Owner Change Order

Project: BID 24-052 Ft Bend County Fresno Community Center FBC PURCHASE ORDER NO: 242273 Contractor: (TEALCO) Teal 1335 Brittmoore Rd Houston Texas 77043	Change Order Number: 0006 Title: Owner Change Order 03 Change Order Date: Oct 6, 2025 Architect's Project No: Contract Date: 5/14/24
---	---

ARCHITECTURAL SUPPLEMENTAL INSTRUCTION NO. #10

DATE: May 6, 2025
PROJECT: Fresno Boys & Girls Club
LOCATION: 1031 W Sycamore Rd Fresno, Tx 77545
PROJECT NO. N032023
DISTRIBUTION: Ft Bend Procurement Department
DELIVERED VIA: Email
NO. PAGES: 3 pages
PREPARED BY: Smith & Company Architects, Inc

A4.01

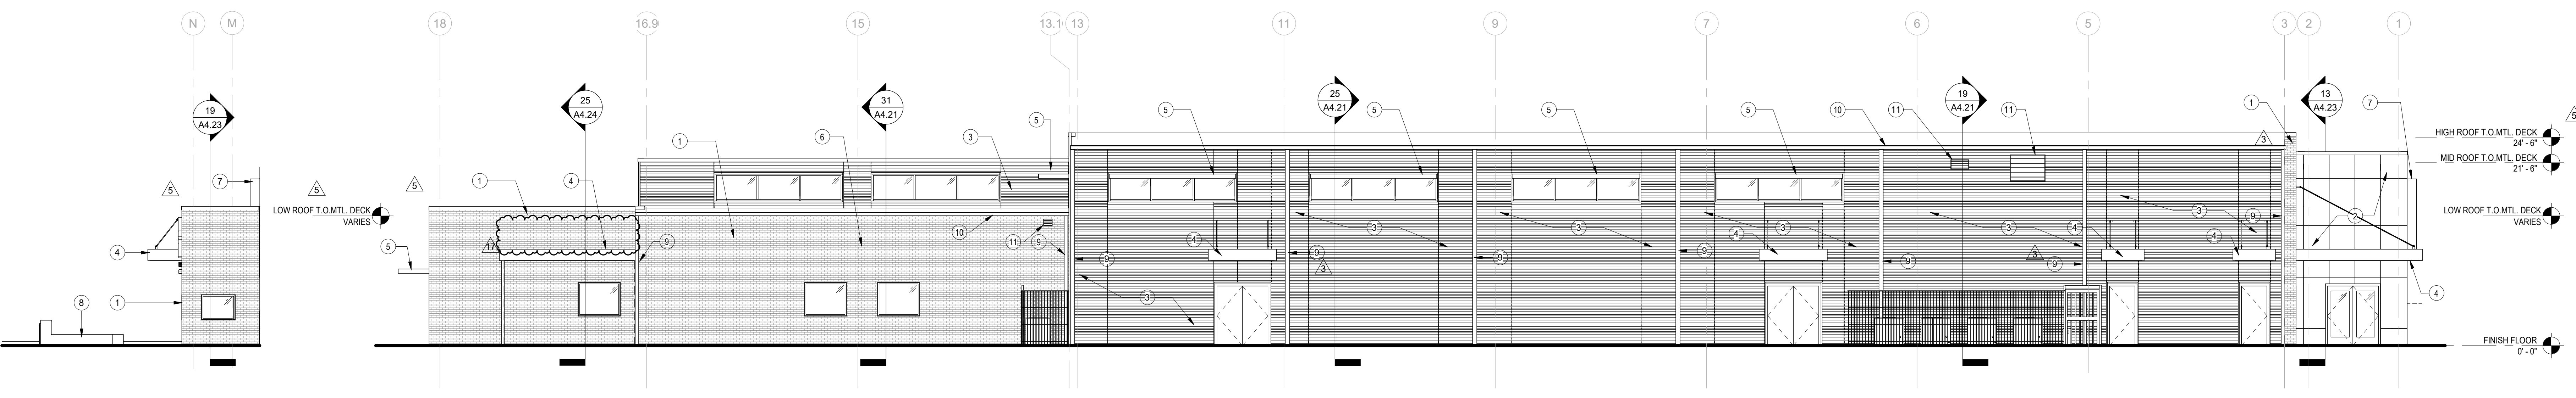
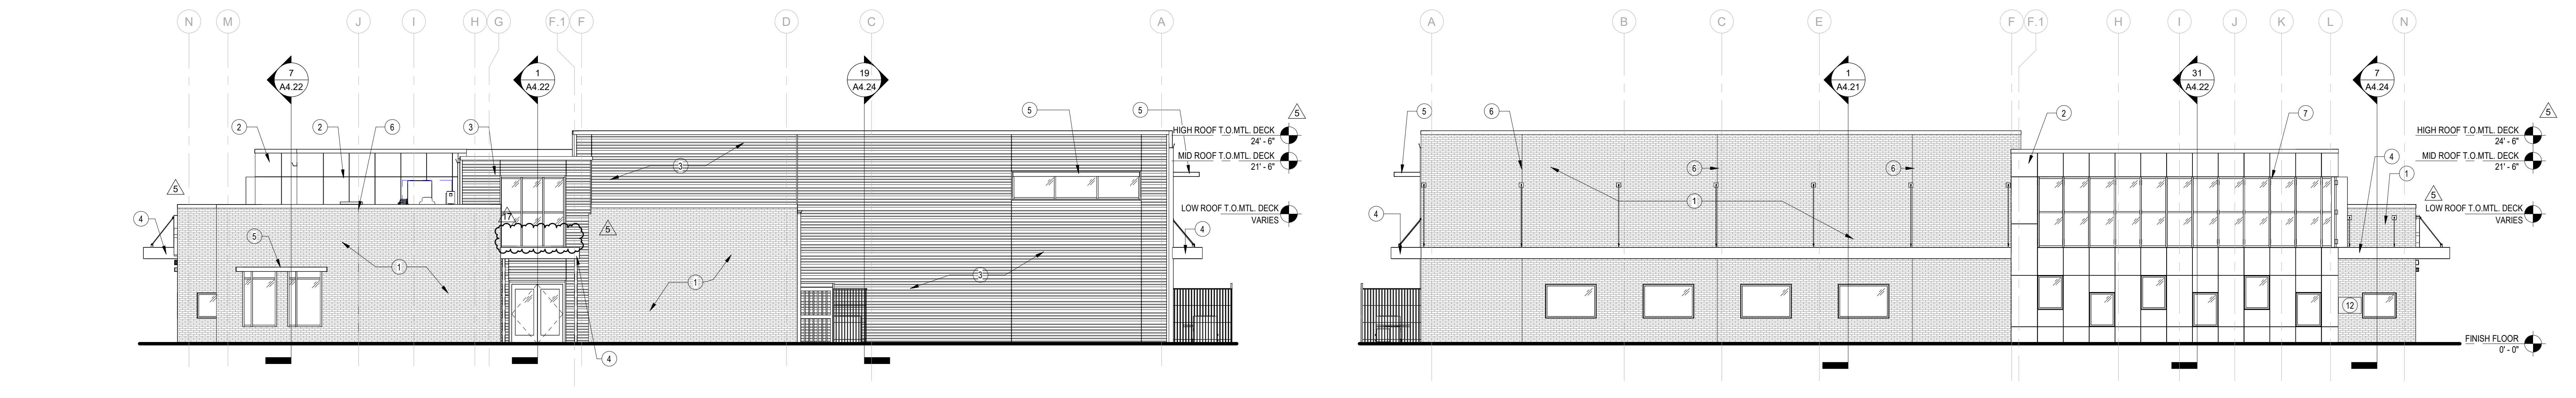
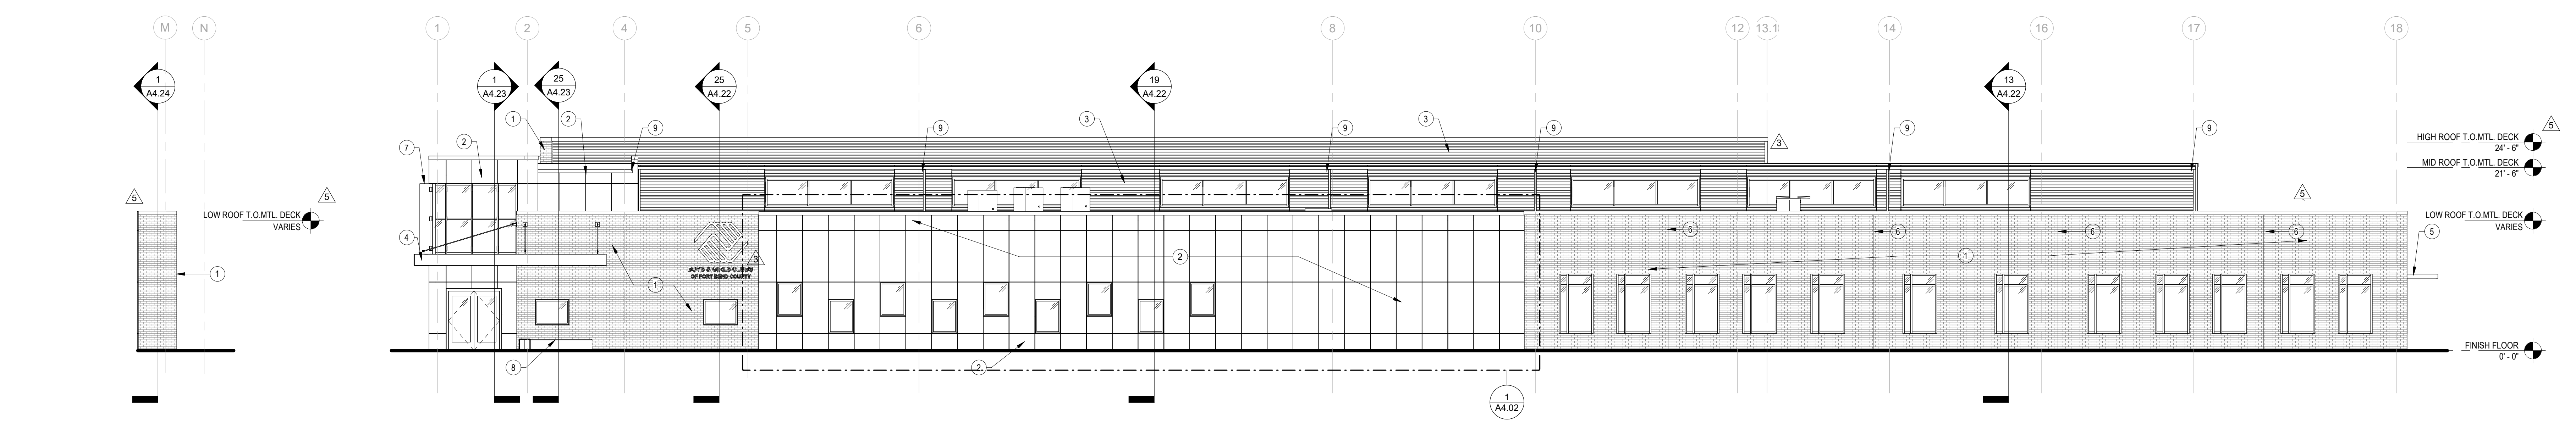
1. Delete Sheet A4.01 EXTERIOR ELEVATIONS dated August 30, 2024, and replace with A4.01 EXTERIOR ELEVATIONS revised May 6, 2025.
2. Delete Sheet A4.24 WALL SECTIONS dated August 30, 2024, and replace with A4.24 WALL SECTIONS revised May 6, 2025.

ROOF FRAMING PLAN

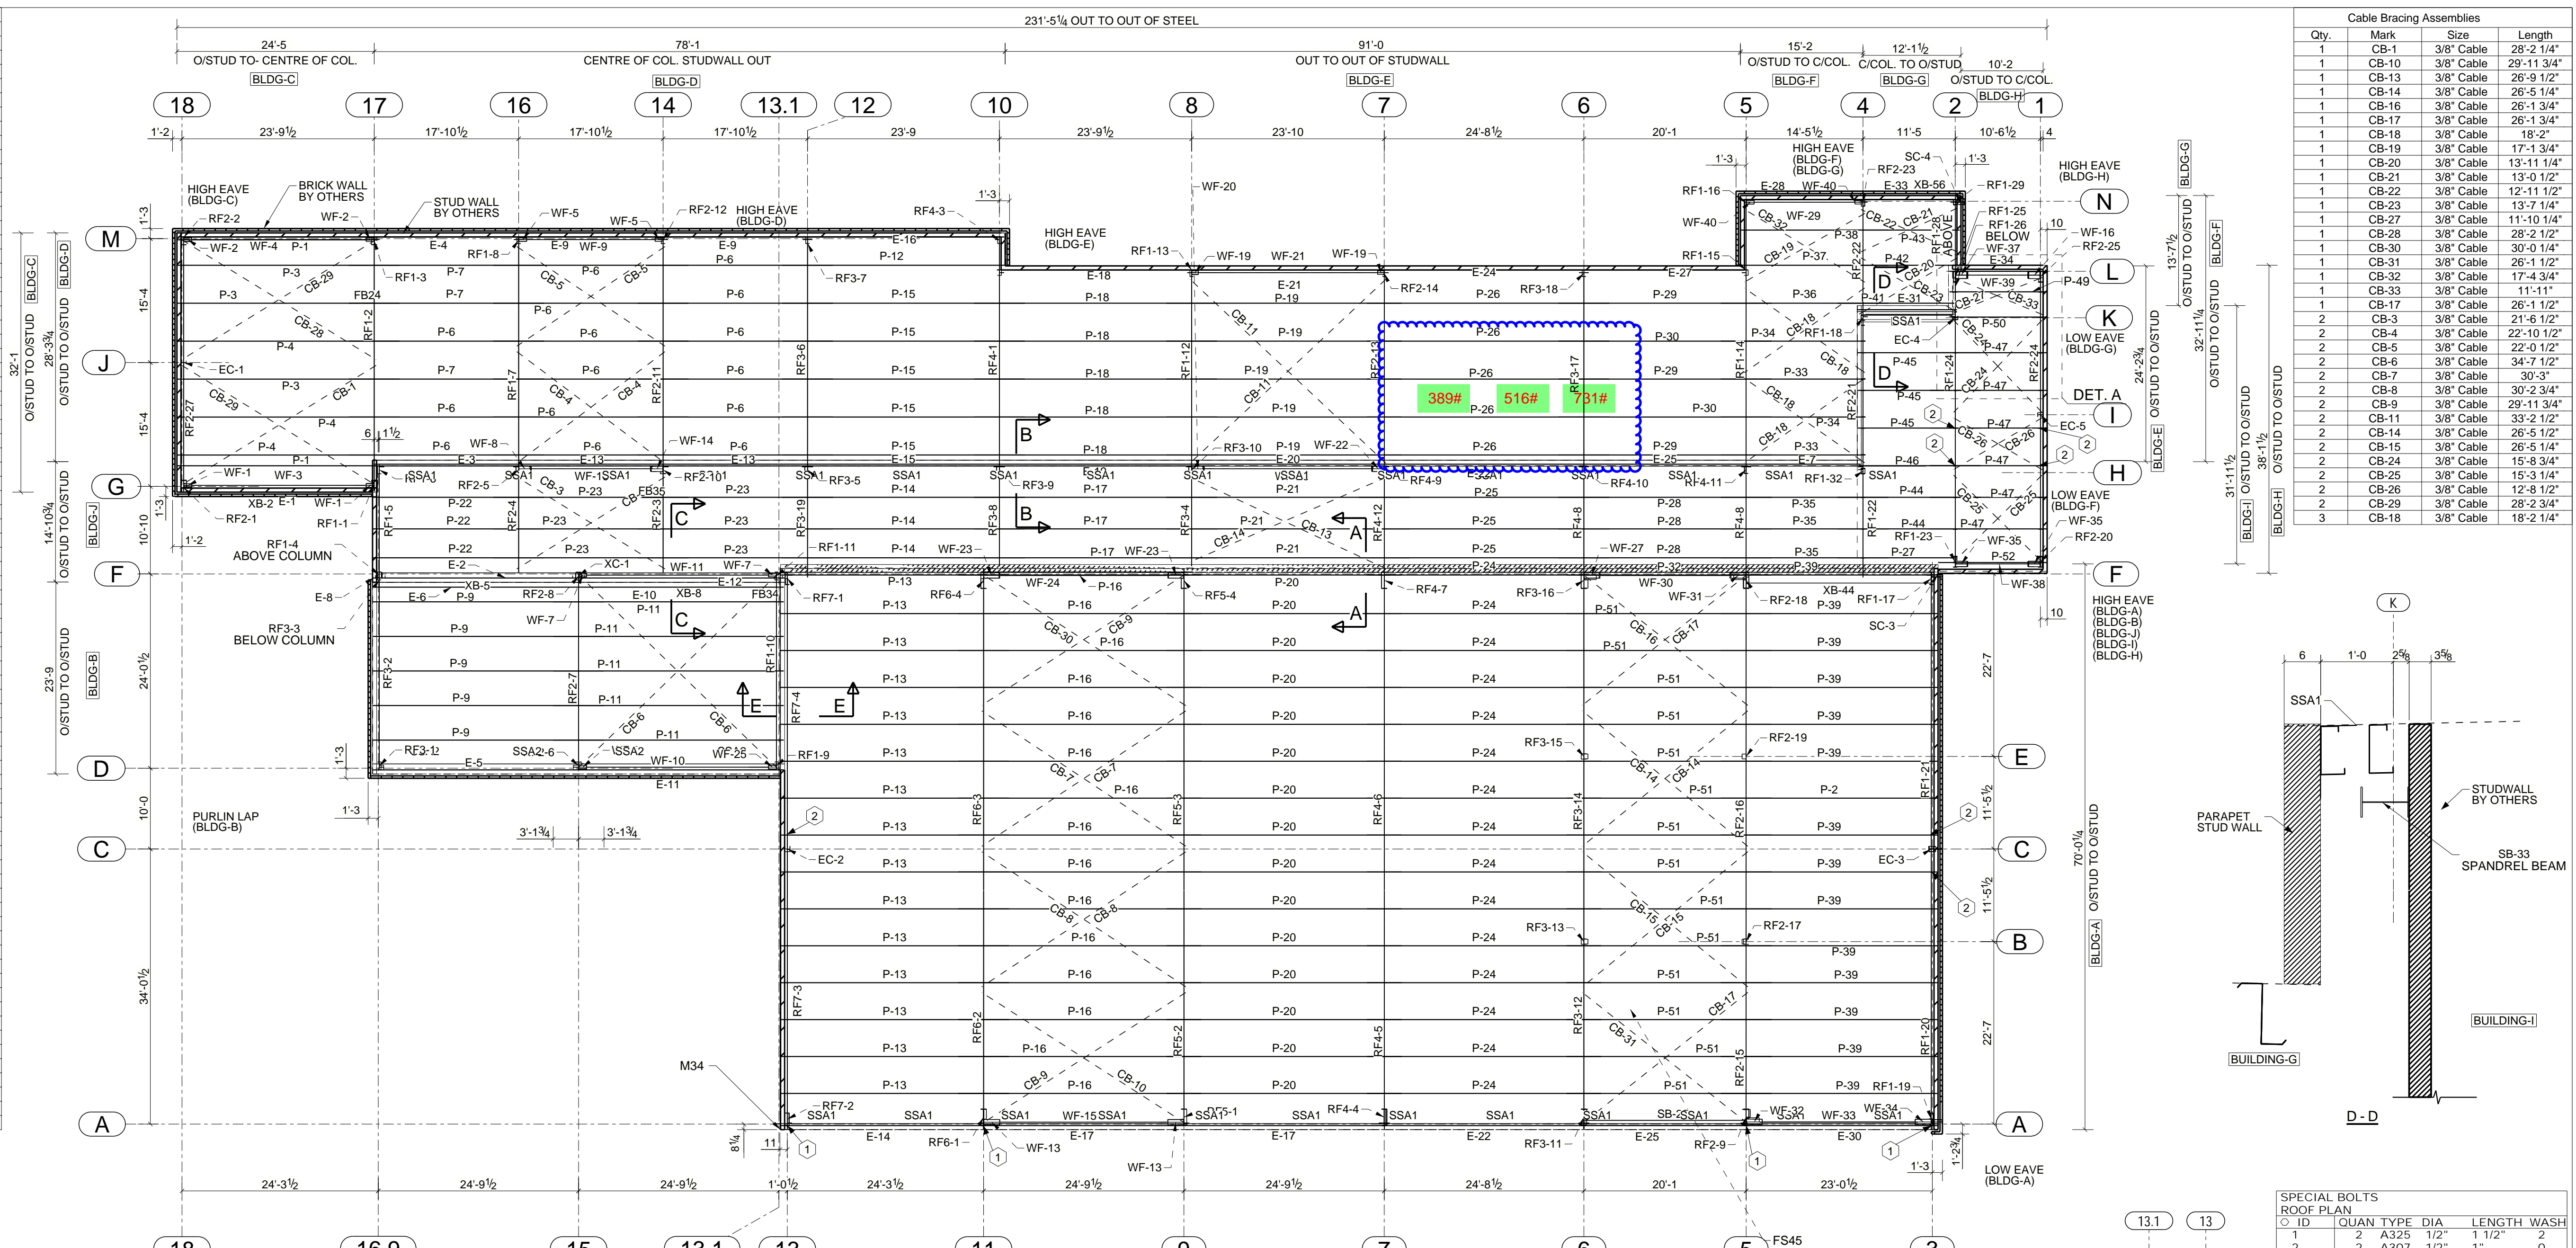
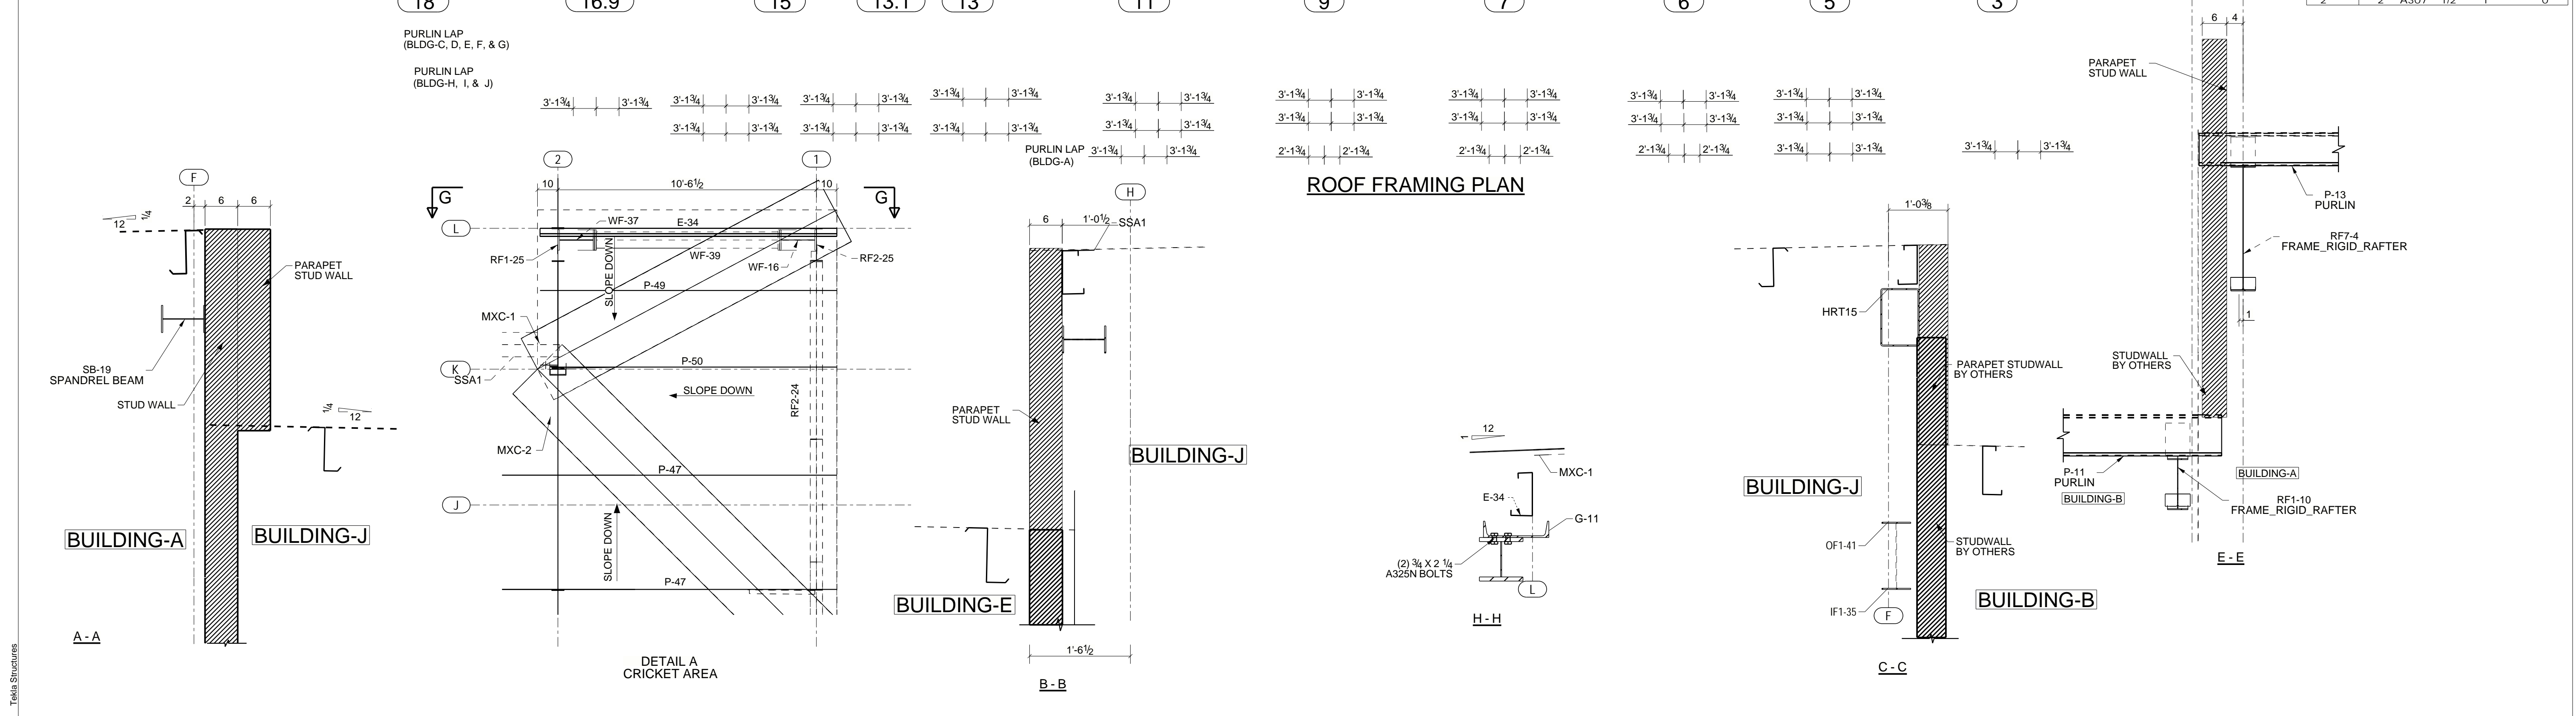
1. Provide and install additional galvanized steel support (W Beam and Pipe) per the attached sketch to support additional equipment to be placed on the roof. Located along GL I between FLs 6 & 7.
Weights of units as follows:

- (1) at 389#
- (1) at 516#
- (1) at 731#

Exhibit:

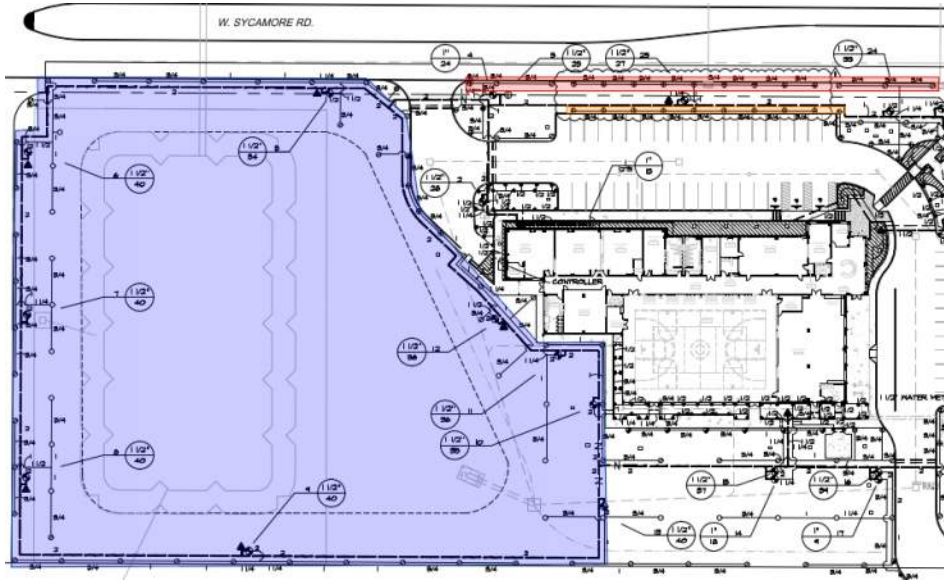
- *Any work outside the scope specifically called out above.*
- *Any landscape changes.*
- *Warranty for plants and plant material within the blue area on the Exhibit below.*

- Any landscape changes.
- Warranty for plants and plant material within the blue area on the Exhibit below.

- Any work outside the scope specifically called out above.
- Any landscape changes.
- Warranty for plants and plant material within the red area on the Exhibit below.

- Any work outside the scope specifically called out above.
- Any landscape changes.
- Warranty for plants and plant material within the orange area on the Exhibit below.
